Beacon City School District

Reconstruction to
Beacon High School
Rombout Middle School
JV Forrestal Elementary School
Sargent Elementary School
South Avenue Elementary School

Addition and Alterations to Glenham Elementary School

BID Addendum No. 4 to Drawings and Project Manual

EA01B Revised First Floor Demolition Plan EA02B Revised First Floor Demolition Plan

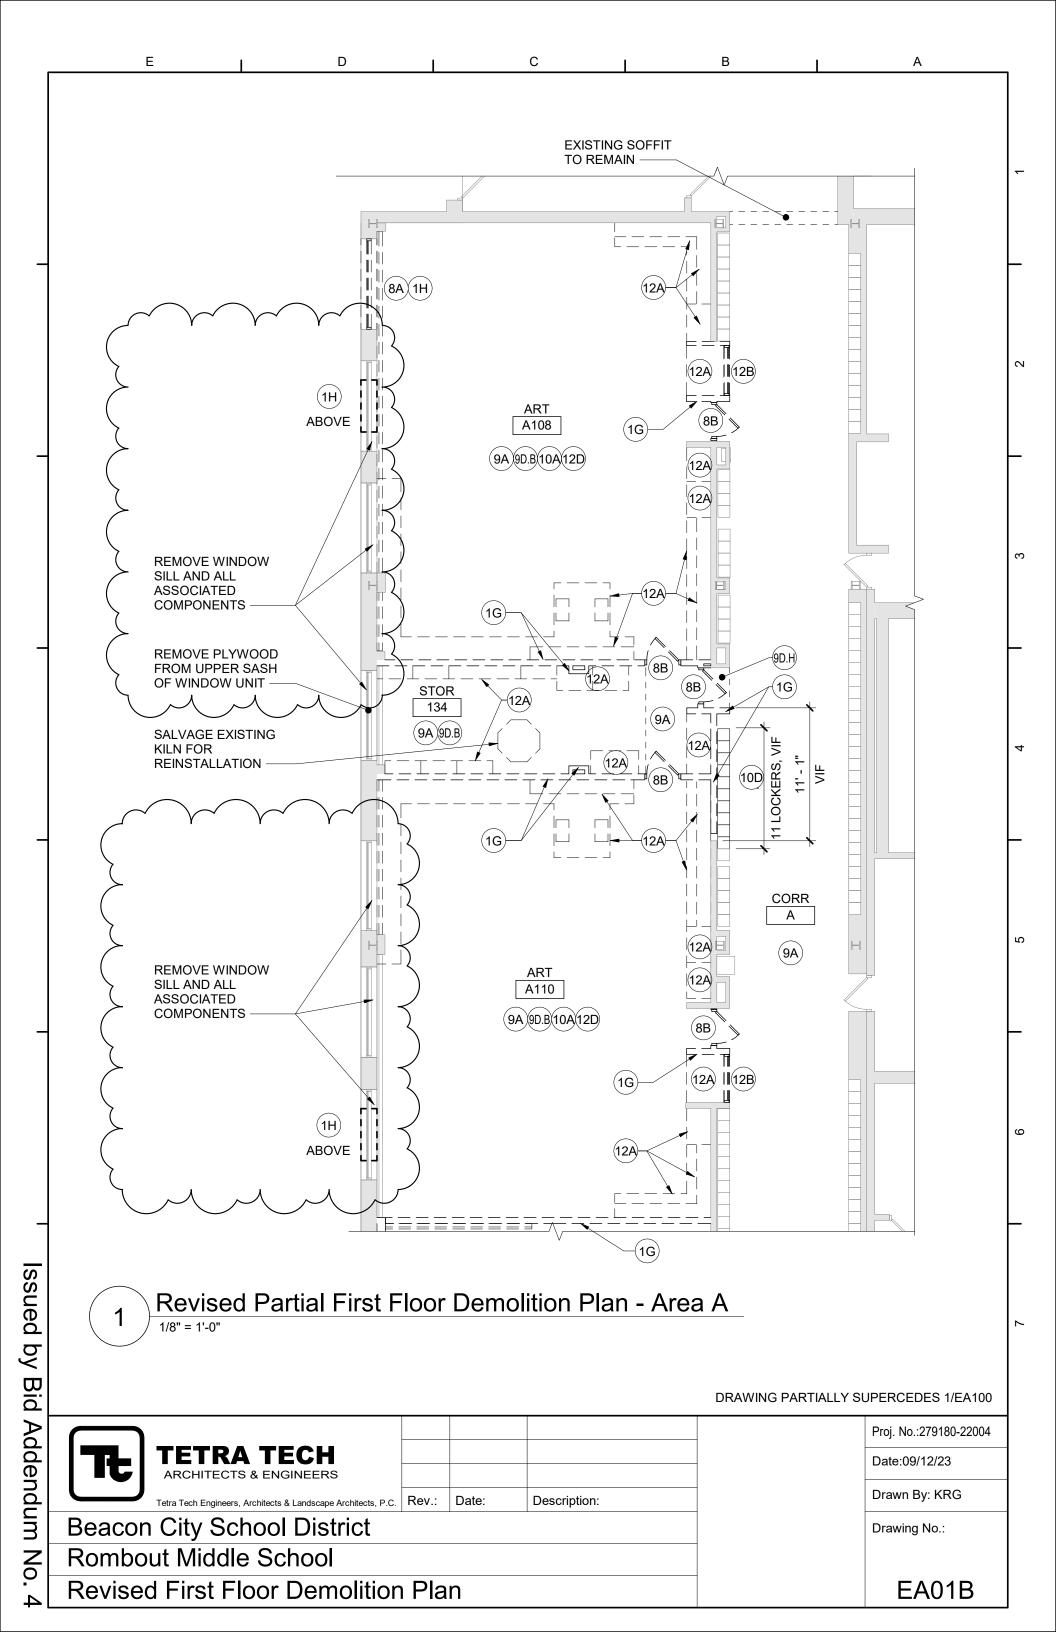
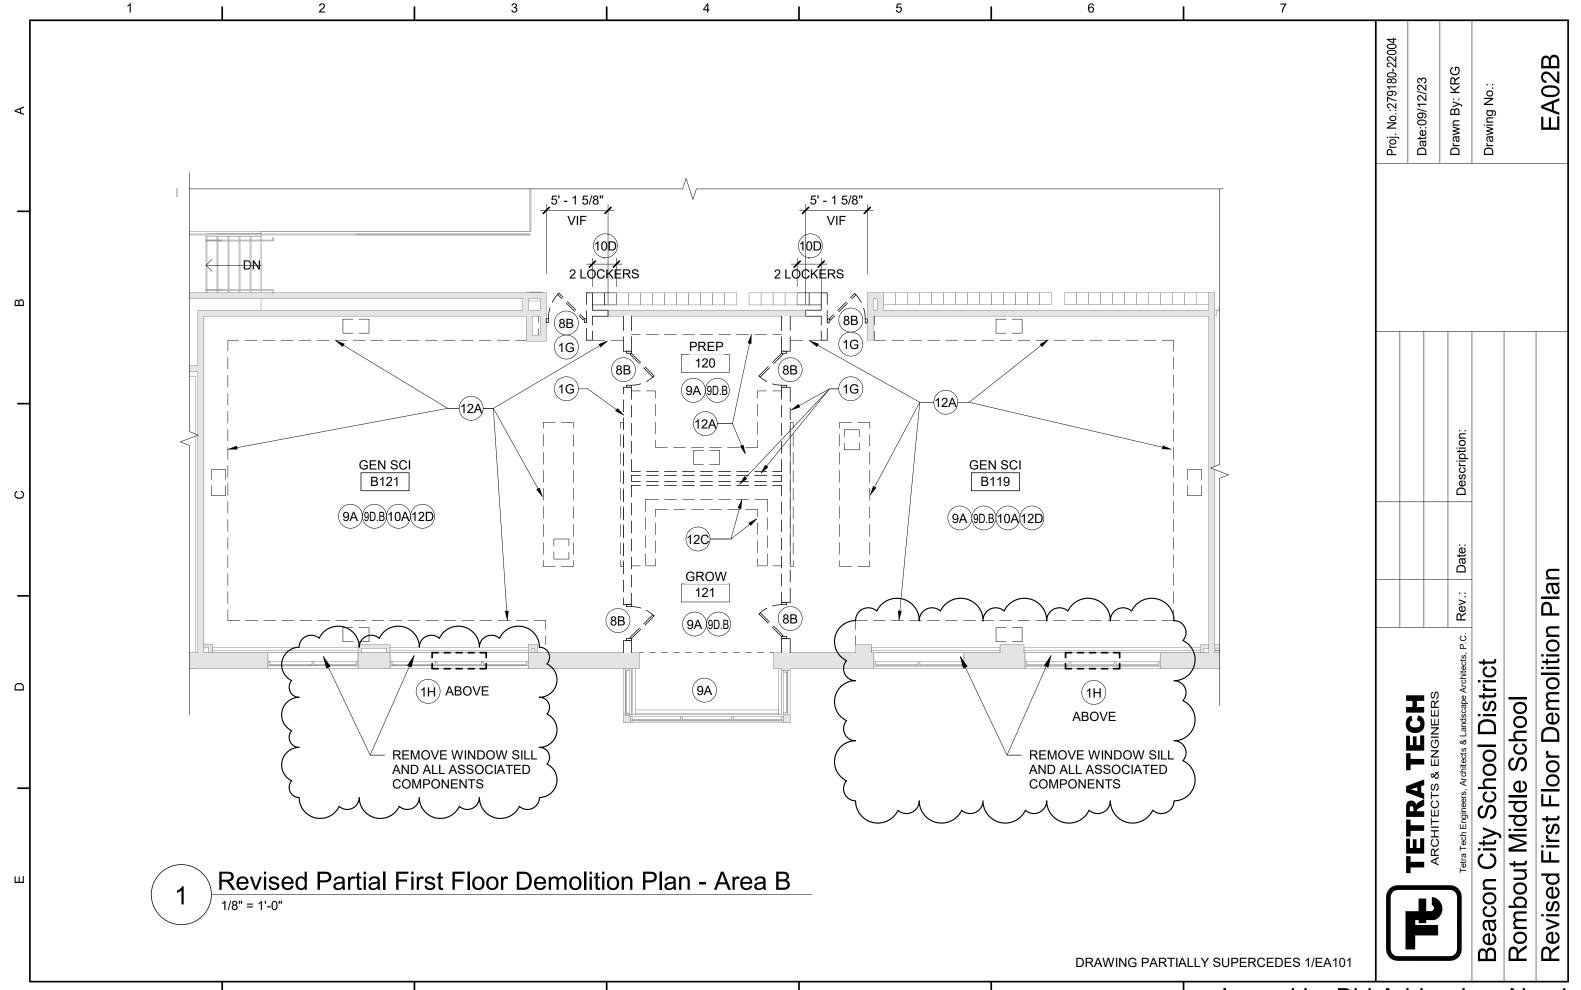
ITEM 4-C-7: Refer to DRAWING EA100

1. Detail 1, <u>AMEND</u> as shown on Drawing EA01B attached to this addendum.

ITEM 4-C-8: Refer to DRAWING EA101

1. Detail 1, <u>AMEND</u> as shown on Drawing EA02B attached to this addendum.
